## Summit at Thompson Creek Staff Report

LD 2022.0109

Subdivide 34.57 acres into 109 single-family residential lots

Approval with conditions

Attachment 1:  
The Summit at  
Thompson Creek  
site plan

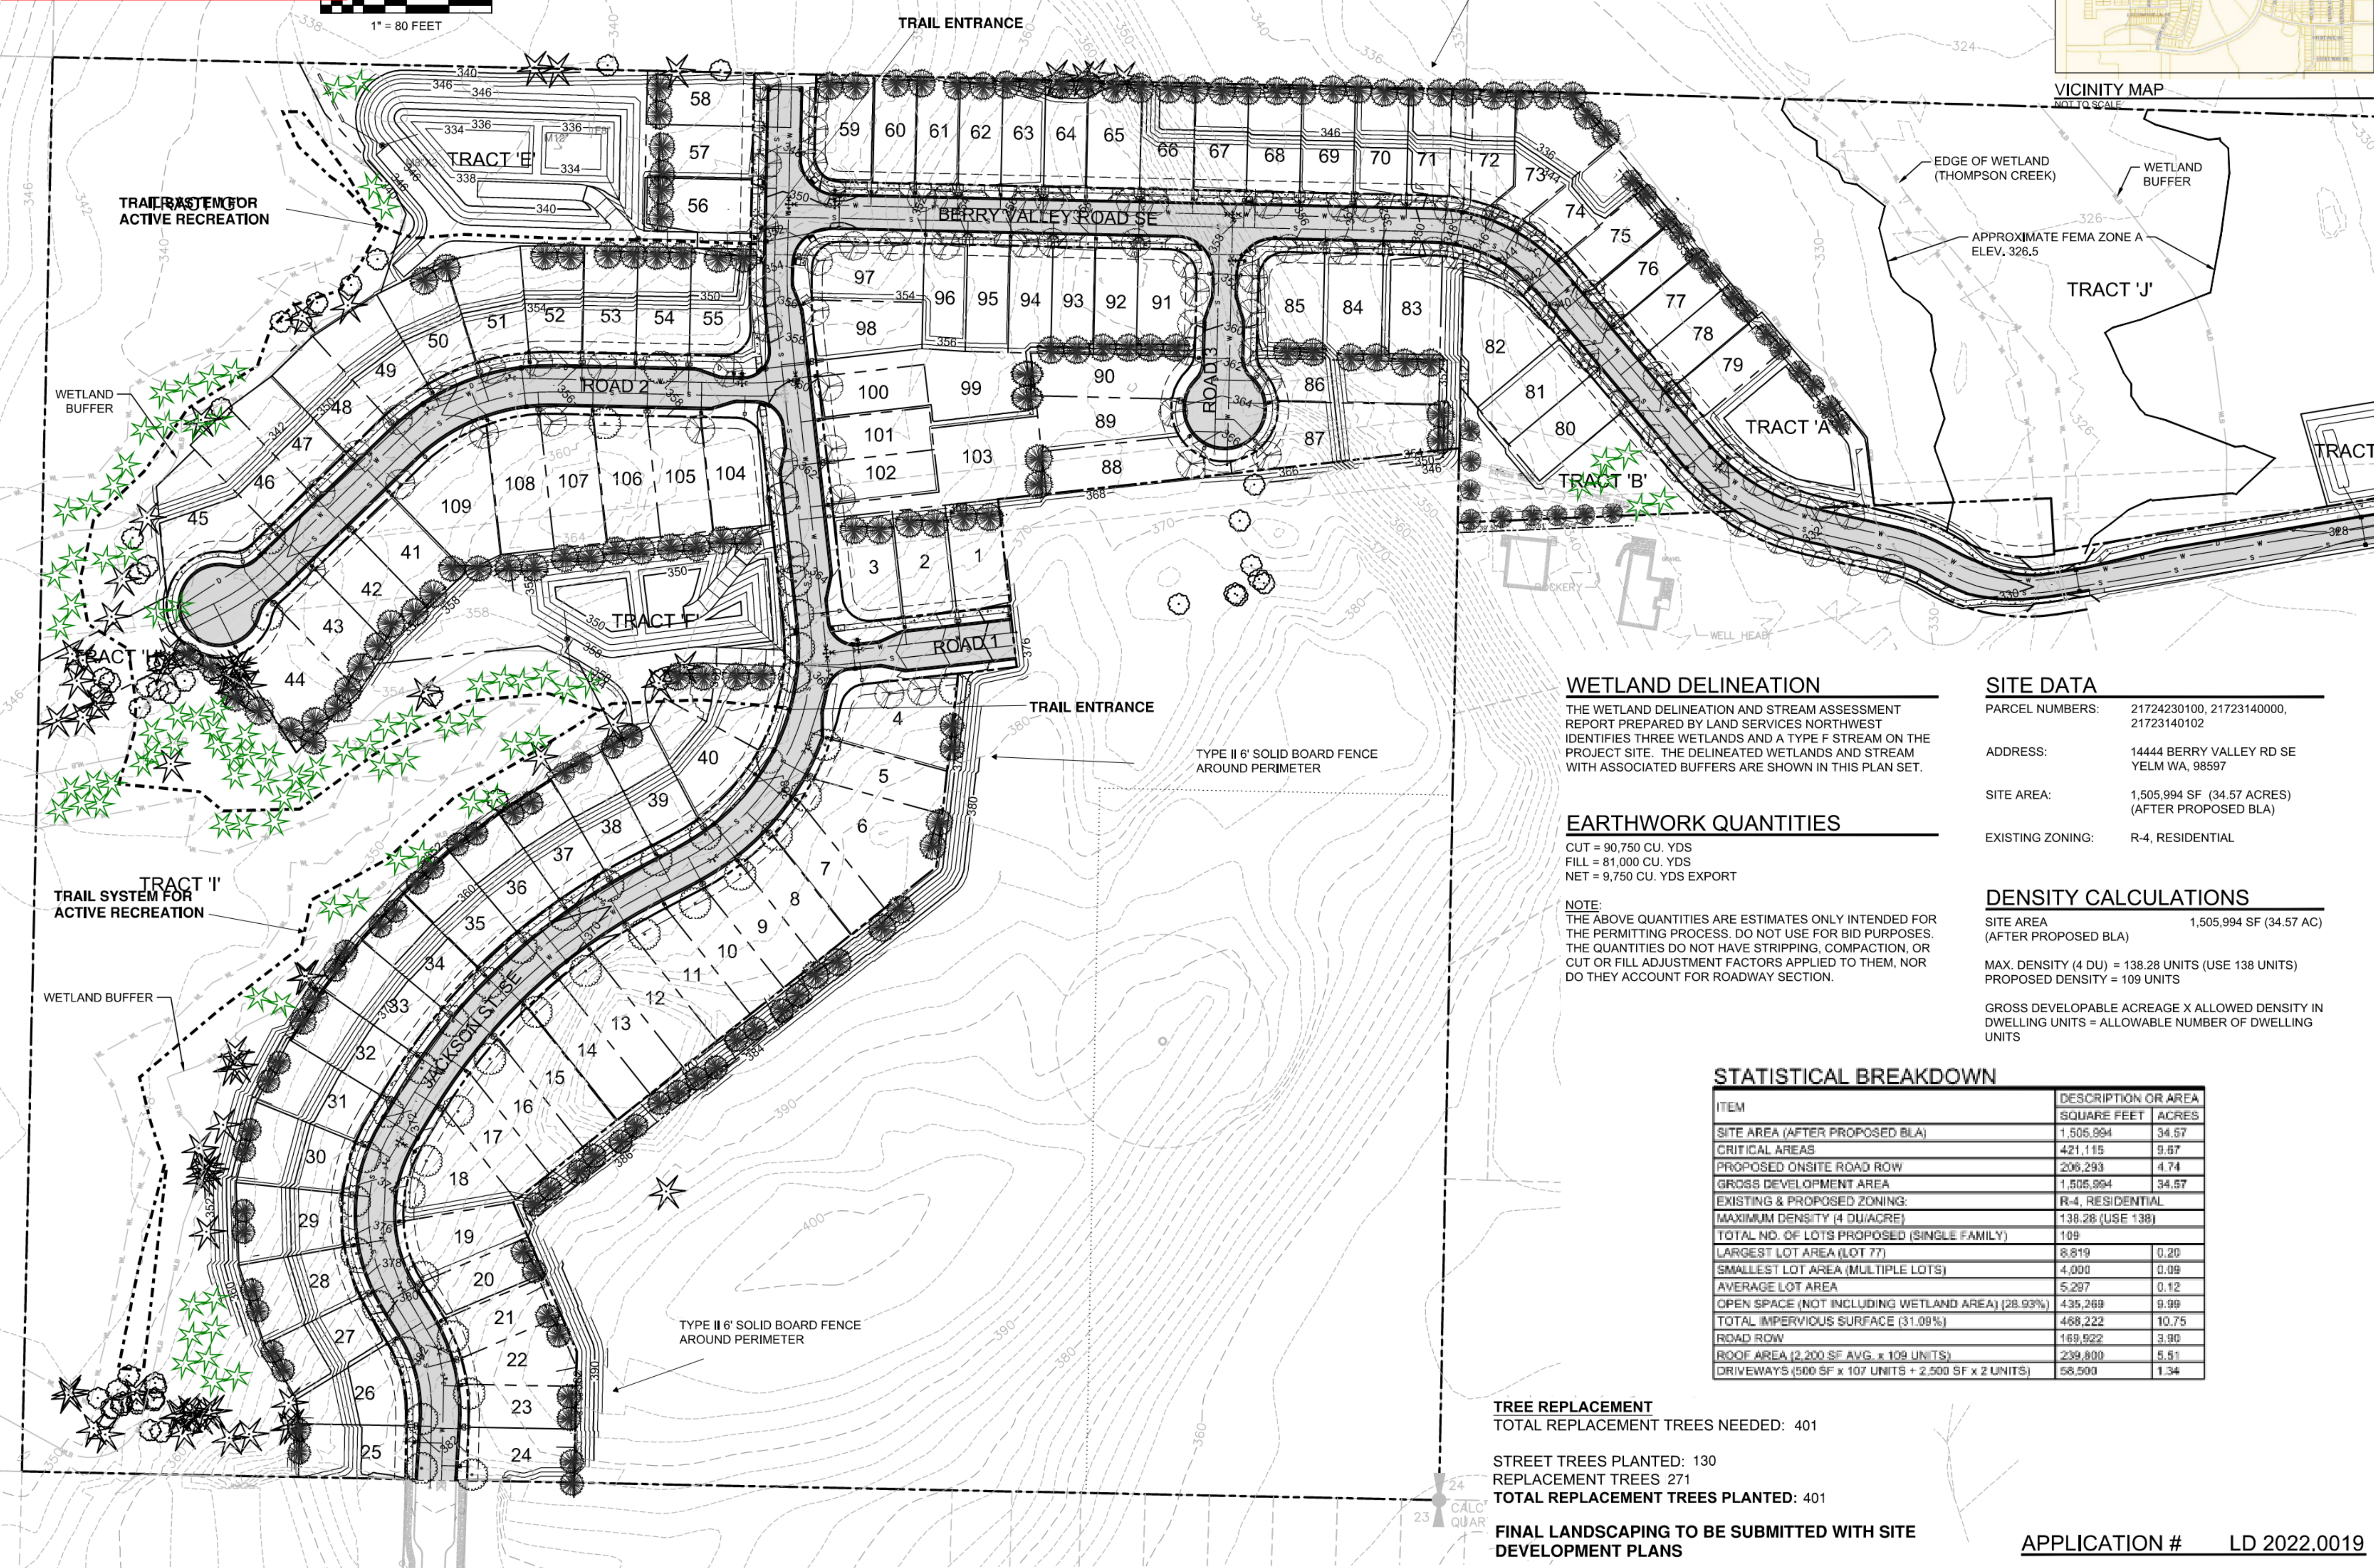
8. SE Thurston Fire Authority has requested two additional fire hydrants: one at the cul-de-sac at the termination of internal 'Road 2' and one near Thompson Creek. The exact location and provision of fire hydrants is finalized during Civil Plan Review. The applicant shall submit a fire hydrant plan that is subject to review and final approval during Civil Plan Review.

14. When the applicant submits their final plat application, the tract of land labeled 'Tract H' on the attached site plan shall be dedicated to the public right of way to provide access for future developments to the west of the subject property.

15. The sewer and water utility shall be extended into 'Tract H' to provide for easier access to these utilities for future developments to the west of the subject property. These sewer and water utilities shall be of an appropriate size to accommodate any future development to the west of the subject property. The final design of these utility extensions are subject to final review and approval during Civil Plan Review.
